# 8920A-02A

## S E R V I C E N O T E

### HP 8920A RF Communications Test Set

#### Early Instruments Require Firmware Upgrade

Figure - 1

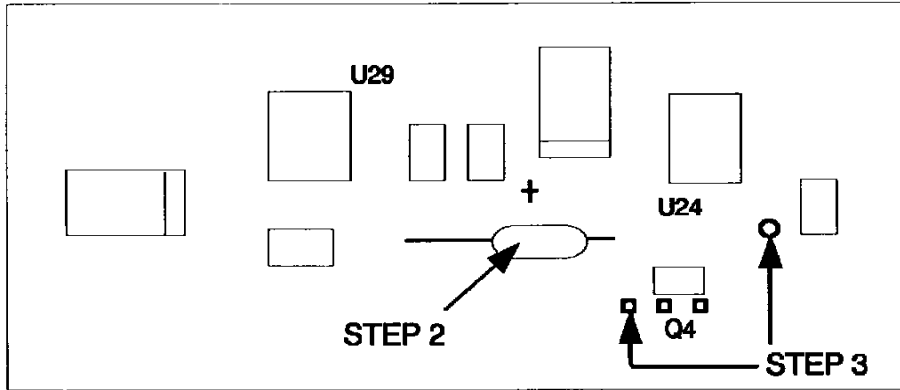
Instruments with these serial prefixes have an A7 Controller assembly that is incompatible with the new A8 Memory assembly which is required to upgrade the firmware.

1. Remove the A7 Controller (DCU) assembly from the instrument. Locate the area of the board shown in Figure 1.
2. Remove the diode in this location and install a 2.87 Kohm resistor.
3. Install a 1 Kohm resistor on the backside (circuit) of the board between these 2 feedthrough holes. Scrape the solder resist off the pads on both sides of the board on the feedthrough hole to the left of the surface mount resistor. Clear the solder out of the feedthrough hole to the left of Q4. It's a tight fit, but the leads will go through the holes.

Figure - 2

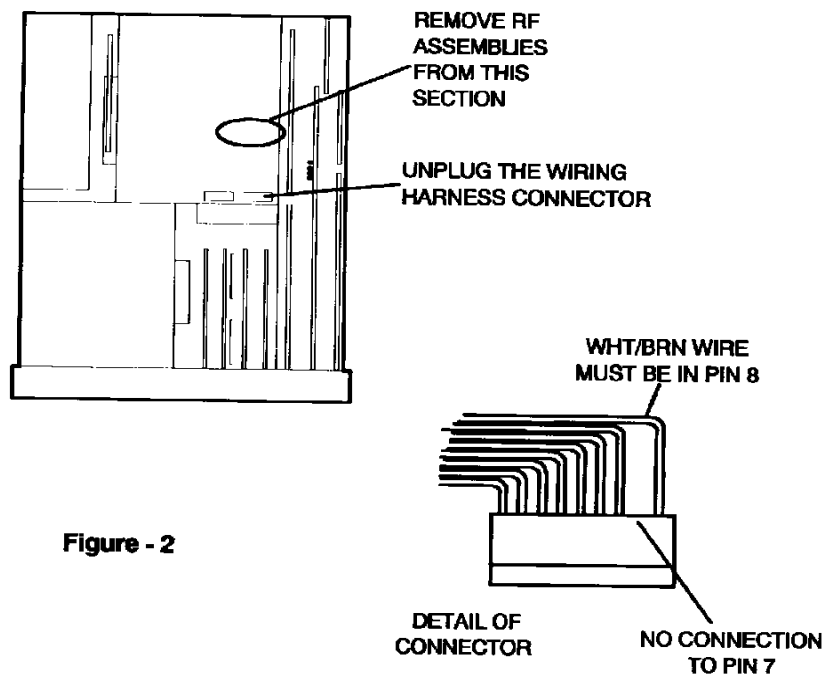
Instruments in this serial prefix range have an error in the main Power Supply wiring harness. This error prevents the processor from identifying whether the power supply is powered in AC or DC mode which prevents detection of a low battery condition.

1. Remove all the RF assemblies from the instrument.
2. Unplug the wiring harness connector shown in Figure 2.
3. The WHT/BRN wire should connect to pin 8 of this connector. See Figure 2. If the WHT/BRN wire is connected to pin 7, it must be moved to pin 8. There should be no wire connected to pin 7.
4. To move the wire insert a small sharp pointed tool into the cutout on the side of the connector body next to the pin to be moved. This should allow the wire to be removed from the connector body. Then insert the wire into the pin 8 position of the connector body.
